Wilmington Boys and Girls Club
Sports Court and Gym Improvements Project
1444 W. Q St.
Wilmington, CA 90744

Request for Proposals
Questions and Answers

Round 2
9/22/17

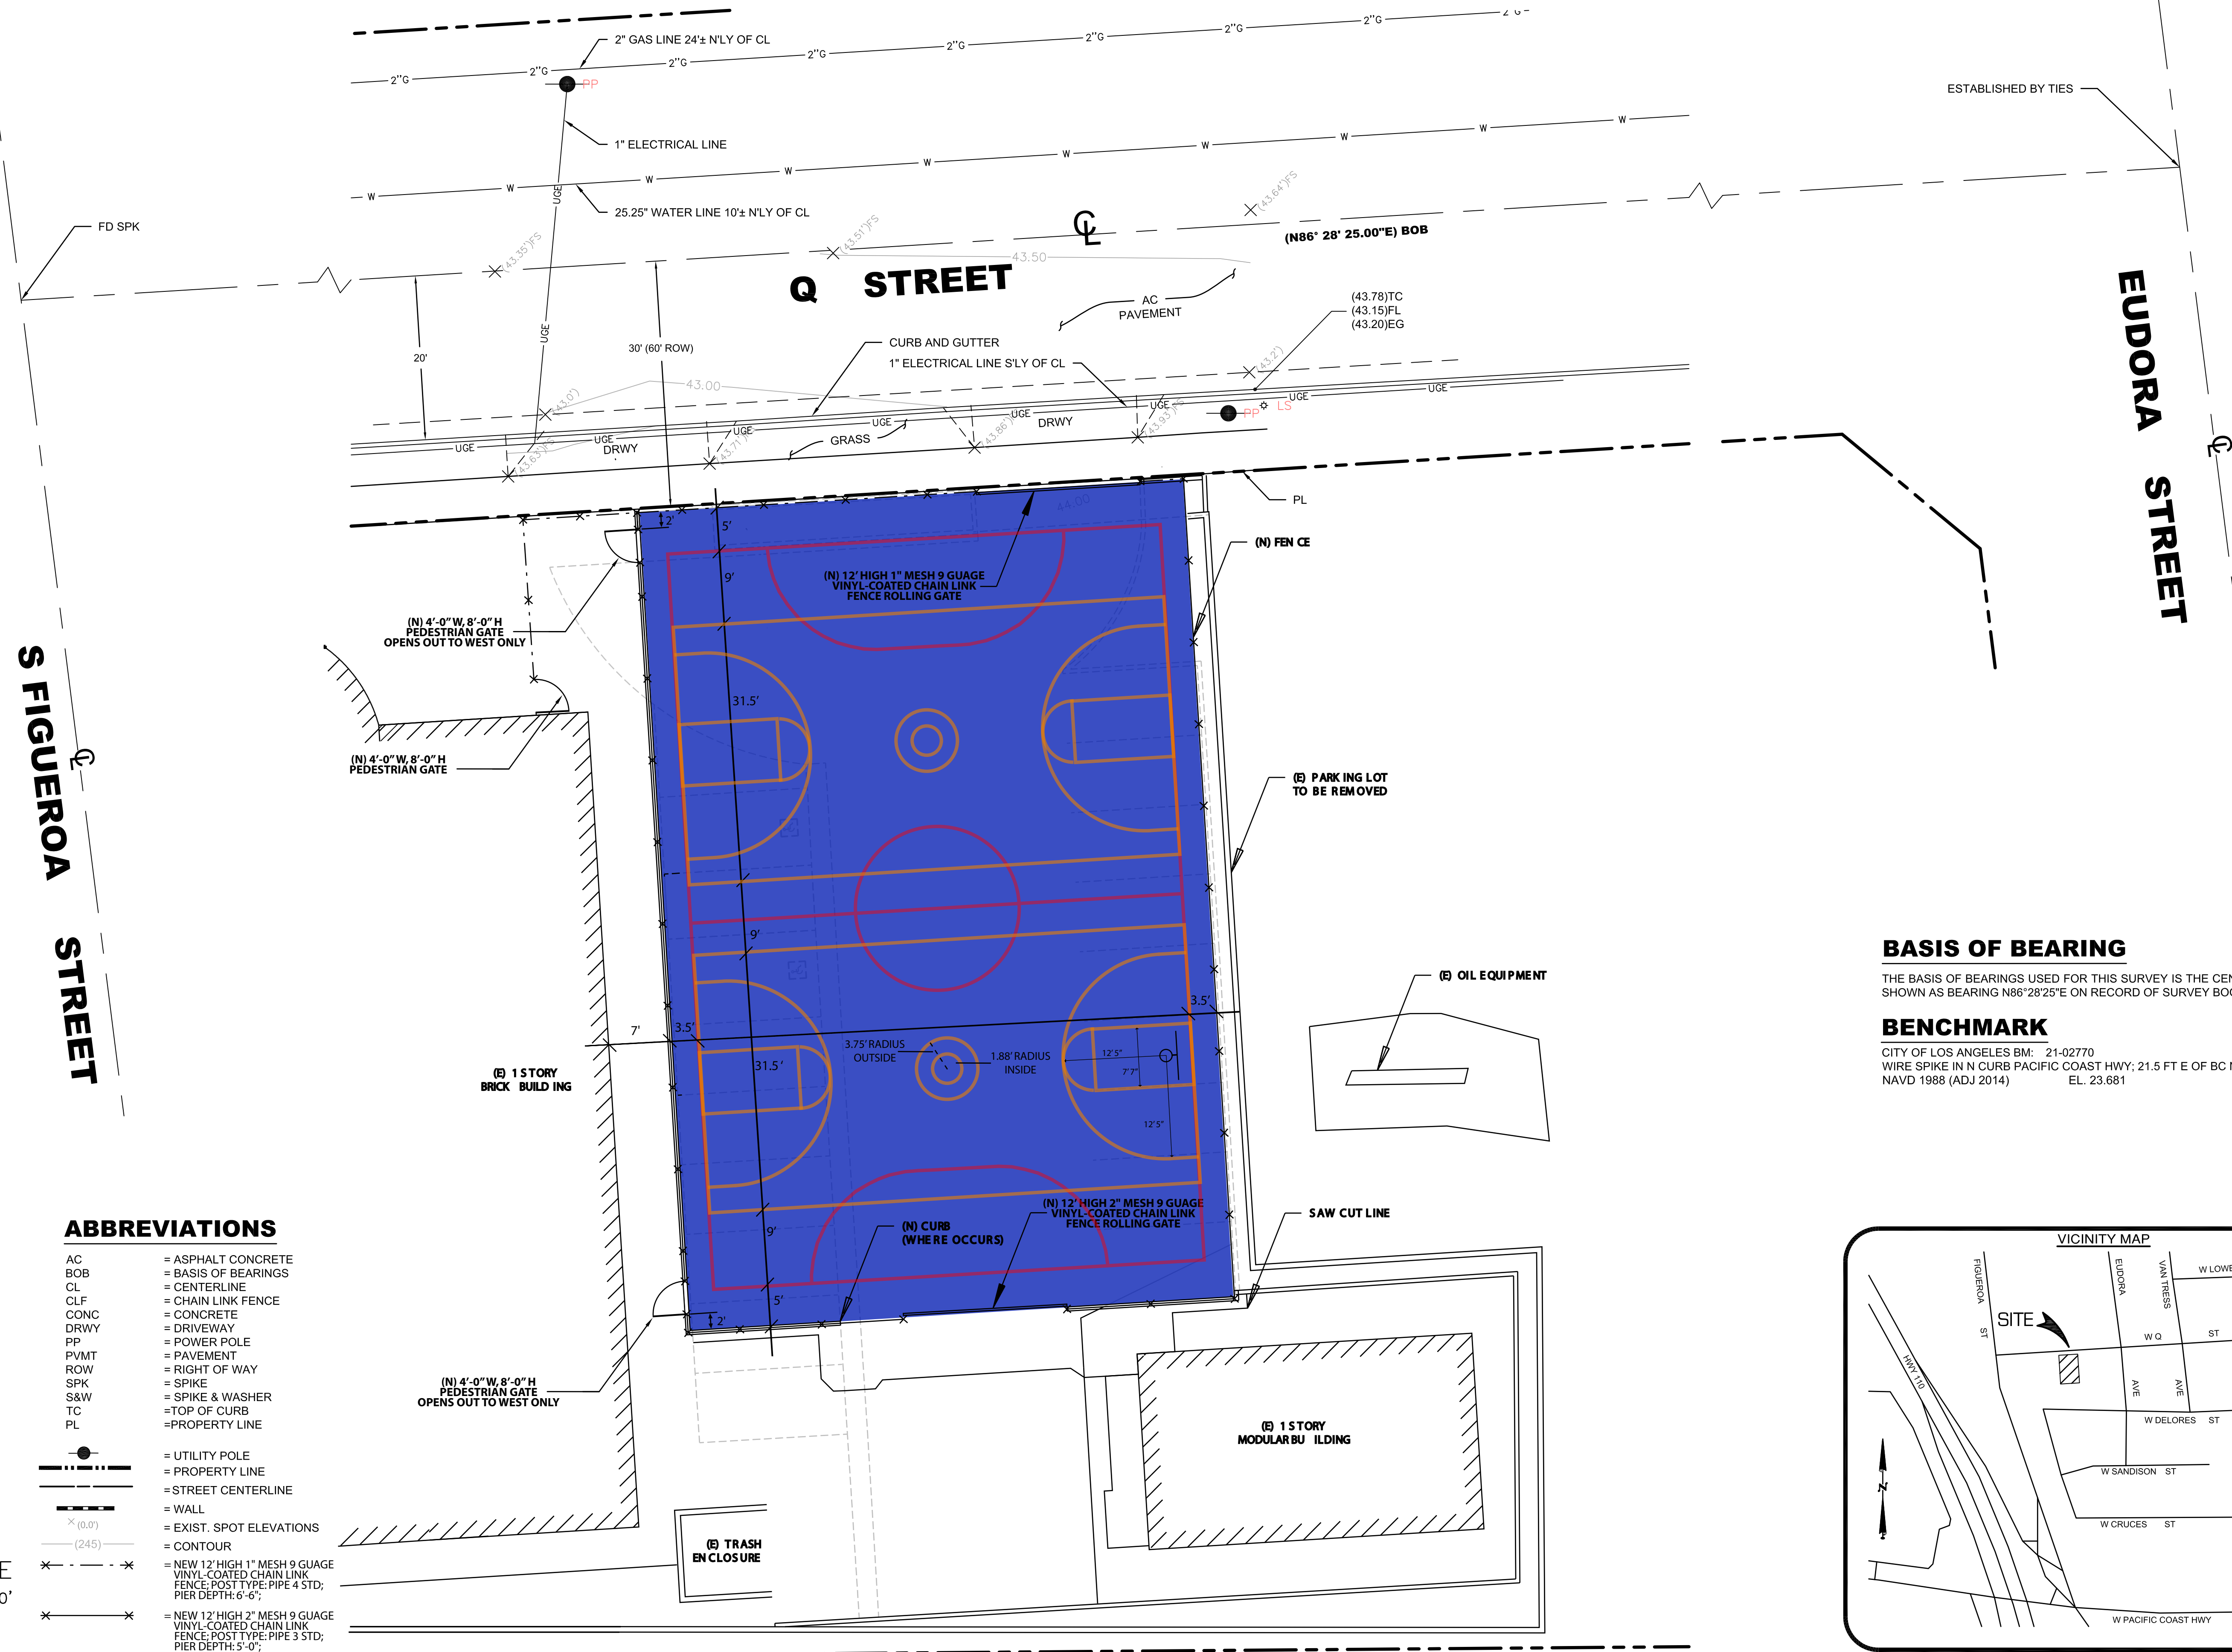
When the gym wall carpeting is removed to install the new padding, how will the padding be installed?

Currently the carpeting is attached to ½ inch plywood which is attached to the concrete wall with metal studs. Remove the carpeting, the wood, and metal studs. Screw the new padding directly onto the concrete. Repair any damage that occurs in this process.

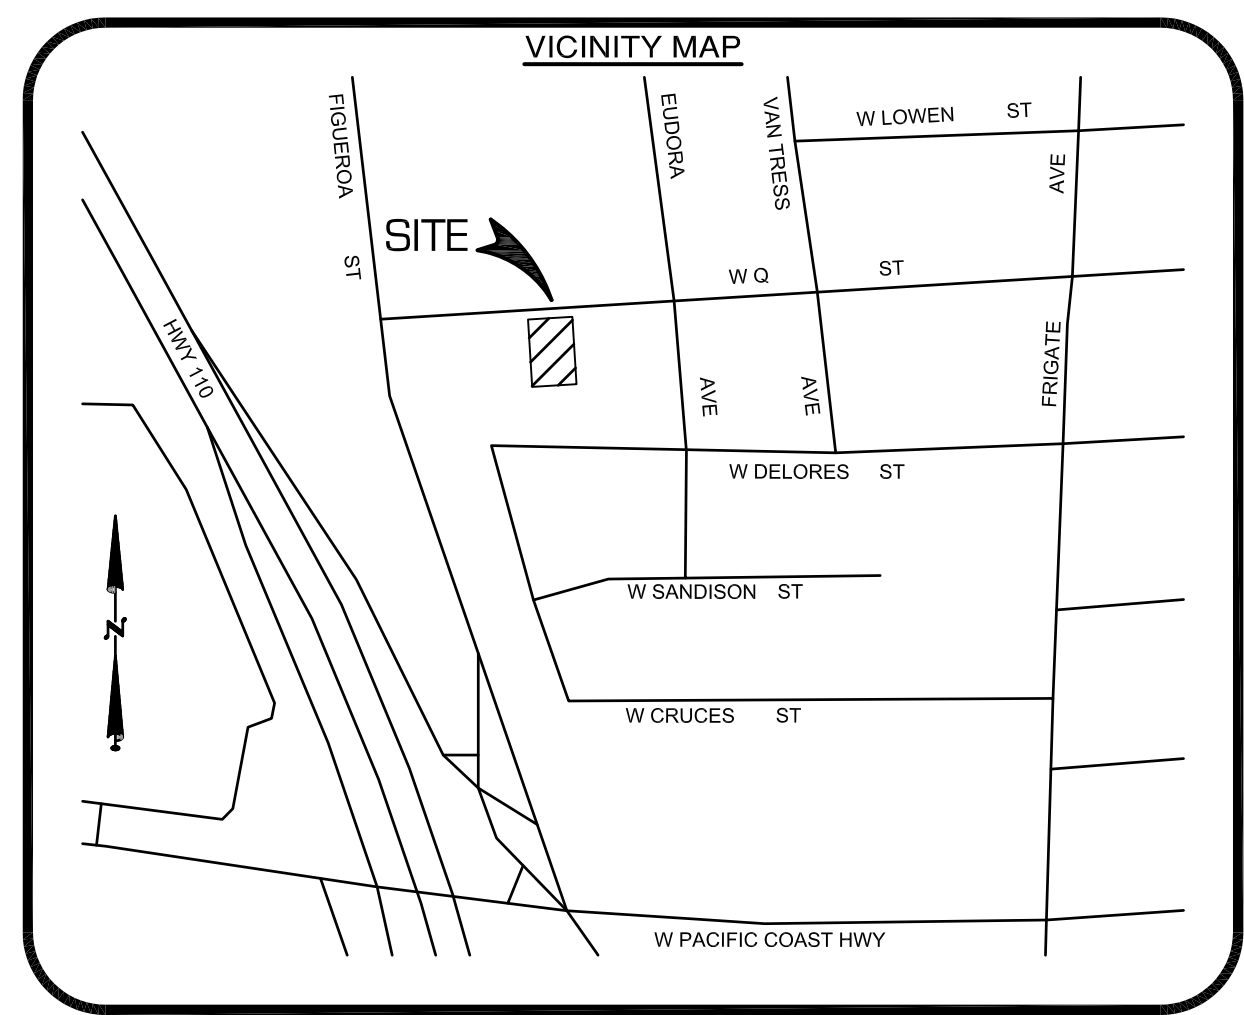
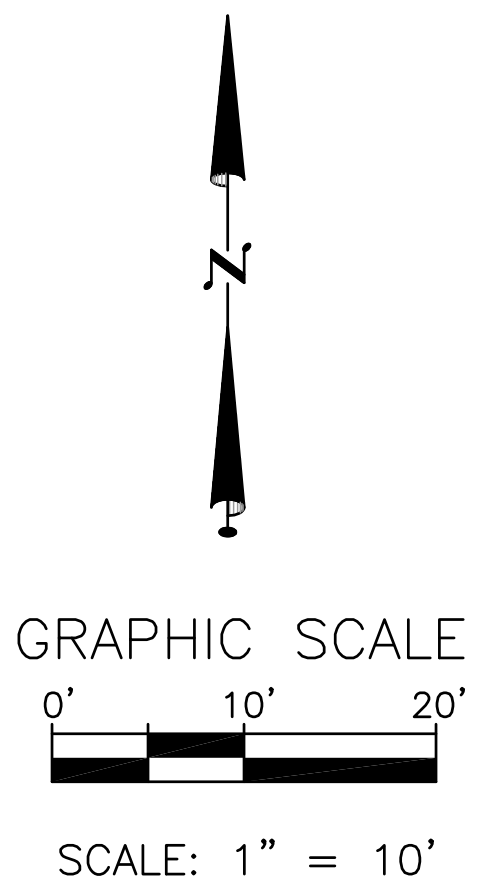
Can you please explain the scope of work for the fencing? Will the fencing all be rubber coated chain-link? What does the 1" mesh and 2" mesh mean?

See the attached SP-1.2 for additional detail on the fencing plan.

The chain-link fence will be 12' high vinyl-coated 9 guage chain link fence. The 9 guage is the measurement of the fencing after the vinyl coat is added. The vinyl coating will be black colored.

All fencing on the north side of the court, including the fencing connecting the northwest corner of the sport court to the northeast corner of the building, will be 1" mesh. All other fencing will be 2" mesh.

The mesh measurement is the distance between the fence wire, measured diagonally.

All fence posts on the north side of the court, including the fencing connecting the northwest corner of the sport court to the northeast corner of the building, are to be "Pipe 4 Std" with Pier Depth of 6'-6", as indicated on page S-2.1 of plans. All other fence posts are to be "Pipe 3 Std" with Pier Depth of 5'-0", as indicated on page S-2.1 of plans.

Please note: Two pedestrian gates are shown on the west side of the sport court fence. These gates must open out towards the building only.
